**Perimeter Wall Stabilization (PWS) Segment 8 Test Parcel No. 803 (TP803)  
Completion Concurrence and Acceptance  
Kingston Perimeter Containment – Segment 8 (RDP-0113-J)**

**EXHIBIT 1**  
**TEST PARCEL 803 ACCEPTANCE**  
KINGSTON ASH RECOVERY PROJECT

**EXHIBIT 2**  
**TEST PARCEL 803 LOCATION**  
KINGSTON ASH RECOVERY PROJECT

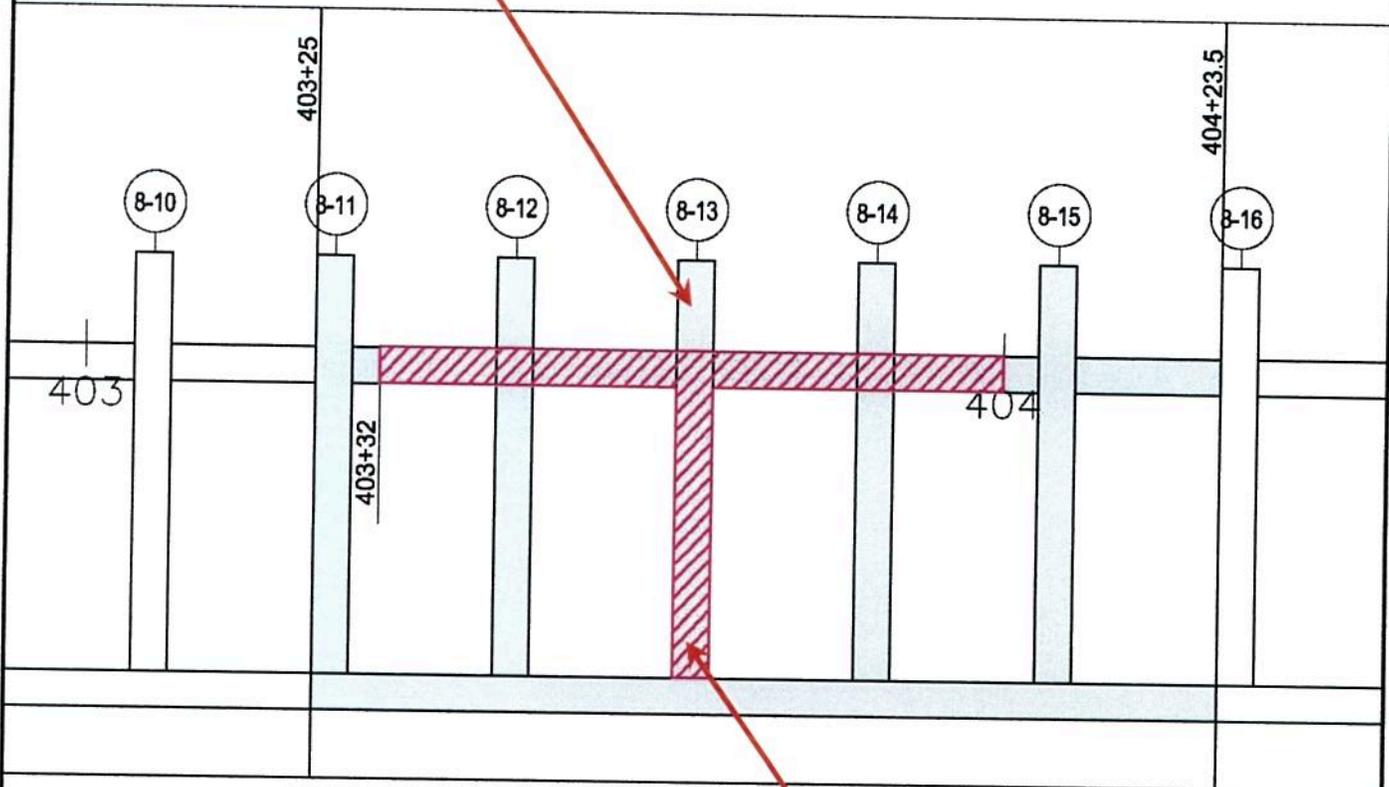
Based on an assessment of the Quality Control documentation (previously defined), and field observations at the time of construction, Stantec recommends that TVA accept the above referenced Test Parcel.
